CHANGE REQUEST NO. ILC-CR-0011	EDMS No: D*xxxxxxx	Created: 1-12-2015
		Last modified: xx-xx-2015

THE REARRANGEMENT OF UNDULATOR POSITRON SOURCE

Relocate the positron booster (PBSTR), ECS (Energy Compressor Section), and PLA (Path Length Adjuster) for the undulator positron source for a better system integration. One cryomodule is added to PBSTR for the operational margin.

Fig.1: Undulator positron source layout in TDR.

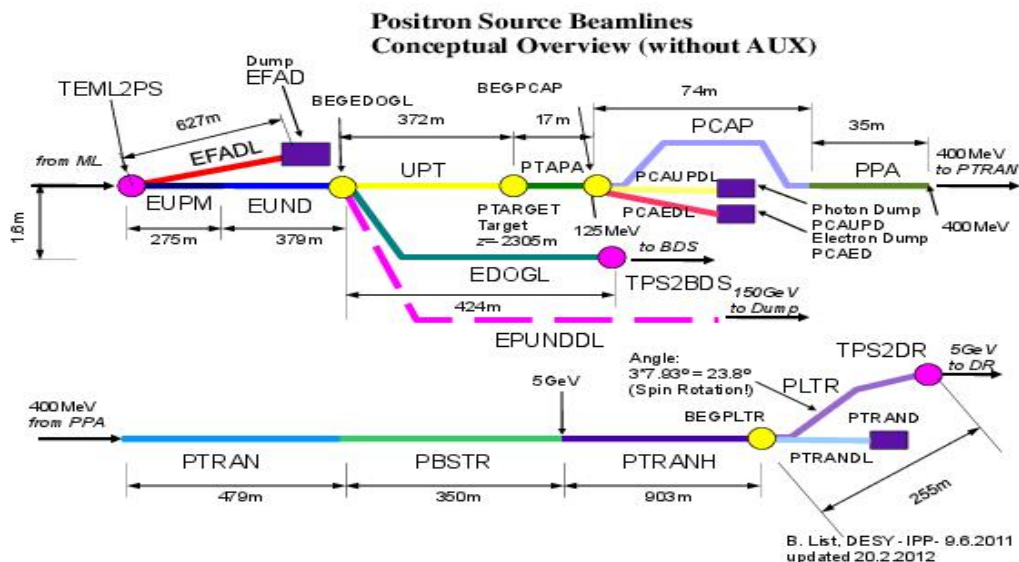
In TDR design, 400 MeV positron after PPA is transported to PBSTR through the 470m long transport line (PTRAN). After it is boosted up to 5 GeV by PBSTR, 5 GeV positron beam is transported to DR through PTRANH and PLTR. PLA and ECS are placed in PTRANH and PLTR, respectively. In this configuration, PTRAN (400 MeV transport line) requires high density quadrupoles. In PTRANH and PLTR in upstream of ECS, the energy spread could be up to 3 or 4 %, but it is less than 0.75%

after ECS. The operation could be complicated because PLA (chicane) and ECS (chicane + RF) are fully coupled. By moving PBSTR at the downstream of PPA, we can omit PTRAN. ECS and PLA are placed after PBSTR in this order to suppress the energy spread in PTRANH and PLTR. It solves also the coupling between PLA and ECS. This rearrangement gives a long vacant (less busy) area which is reserved for further optimization. We propose additional cryomodule for PBSTR for an operational margin. R_{56} of ECS should be 1.4 m instead of 0.7m for better performance.

Fig. 2: Undulator positron source layout in the electron BDS, a) current configuration and b) proposed configuration.

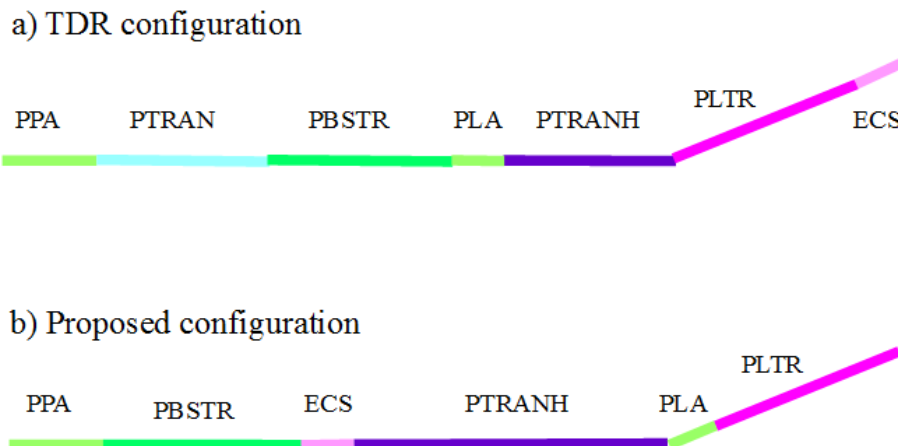
PBSTR, PLA, and ECS are relocated to the upstream as shown in Fig. 2. PTRAN from PPA to PBSTR was set when the undulator positron source was in the middle of ML (150 GeV place), because PBSTR was placed at the downstream of ML. In the relocation of the undulator section to the end of ML, the location of PBSTR did not change and 470m PTRAN was remained. There is no any reasons to keep PTRAN anymore and omit PTRAN is better from the beam optics point of view because the beam

energy in PTRAN is 400 MeV which requires larger bore radius and higher density of quadrupoles. In PTRAN, 119 quads/km is assumed and

it should be compared to 79 quads/km in PTRANH. ECS is originally placed after Spin rotator (PTRANH and PLTR). In this configuration, e+ bunches with larger energy spread ($\pm 2\%$ typically) pass through PTRANH and PLTR and beam quality is degraded by chromatic effects. If ECS is placed in the downstream of PBSTR, the energy spread of the positron beam is compressed and the effect can be much suppressed. In the relocation, PLA should be in downstream of ECS. In TDR configuration, PLA is in upstream of ECS. In this case, PLA and ECS is fully coupled, so that the operation could be complicated. By changing order of ECS and PLA, they are almost decoupled and the operation could be much simpler. The relocation gives about 1km vacant (less busy) area where can be reserved for further system integration. If PLA can be accommodated in PLTR section as shown in Fig. 2(b), the section length can be longer. We propose R_{56} of ECS is 1.4m instead of 0.7m for better performance. We propose to increase 3 cryomodule (1 RF unit) for the operational margin. TDR PBSTR design does not have any margin on the energy.

- Move PBSTR to upstream.
- Move ECS to downstream of PBSTR.
- R_{56} of ECS is 1.4m instead of 0.7m.
- Move PLA to PLTR.
- Add one RF module to PBSTR as a margin.
